- **MISS—VEHICLE MAY STALL AND NOT RESTART—DIAGNOSTIC TROUBLE CODE (DTC) 1298 MAY BE STORED IN MEMORY—7.3L VEHICLES ONLY—VEHICLES BUILT BEFORE 4/11/96**
- **NO START—VEHICLE MAY STALL AND NOT RESTART—DIAGNOSTIC TROUBLE CODE (DTC) 1298 MAY BE STORED IN MEMORY—7.3L VEHICLES ONLY—VEHICLES BUILT BEFORE 4/11/96**
- **STALL—VEHICLE MAY STALL AND NOT RESTART—DIAGNOSTIC TROUBLE CODE (DTC) 1298 MAY BE STORED IN MEMORY—7.3L VEHICLES ONLY—VEHICLES BUILT BEFORE 4/11/96**

**Article No.
96-19-9**

FORD: 1995-1996 ECONOLINE

Figure 1 - Article 96-19-9

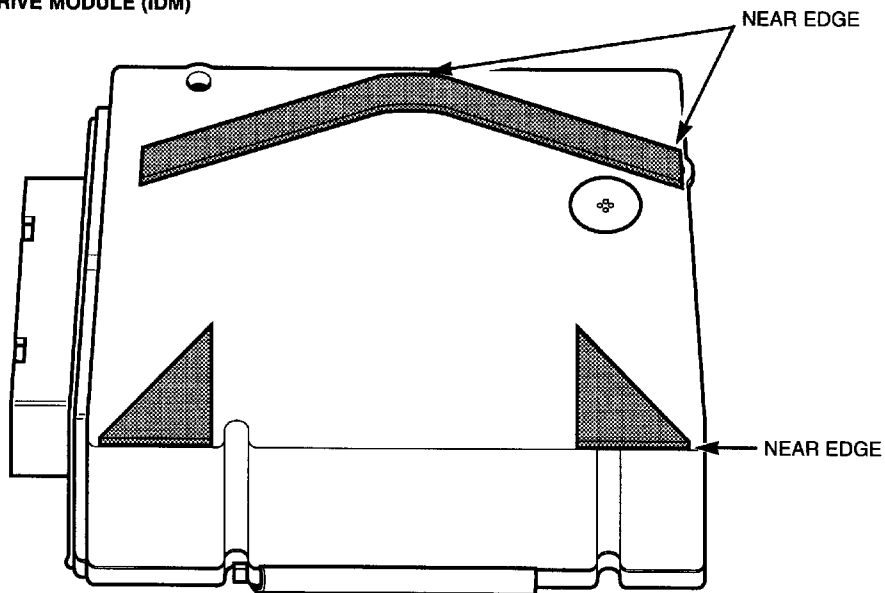
Some 7.3L diesel vehicles may experience an engine miss where the engine may stall and not restart. Diagnostic Trouble Code (DTC) 1298 may be stored in memory. This may be caused by water intrusion into the Injector Drive Module (IDM).

Replace the IDM and install foam pad around the IDM. The foam pad and the revised IDM should reduce the possibility of water intrusion into the IDM. Refer to the following Service Procedure for details.

6. Remove the IDM mounting bolt - body side of ground strap.
7. Remove the IDM from the vehicle. Tilt the IDM from side to side and listen for water. If a sloshing sound is heard, replace the IDM with the foam pieces.
8. Install a revised IDM (F6TZ-12B599-AA) with foam installed on the IDM as shown in Figure 1. Be certain to protect the breather vent.
9. Install the IDM back into the vehicle being careful not to disturb the foam.
10. Reinstall the IDM mounting bolt and torque the bolt to 9-11 N•m (77-99 lb-in).
11. Install the IDM connector and torque the bolt to 5-7 N•m (47-63 lb-in).
12. Reinstall the Q bottle and reconnect the batteries.
13. Perform an injector "buzz" test using NGS to verify the repair is complete.
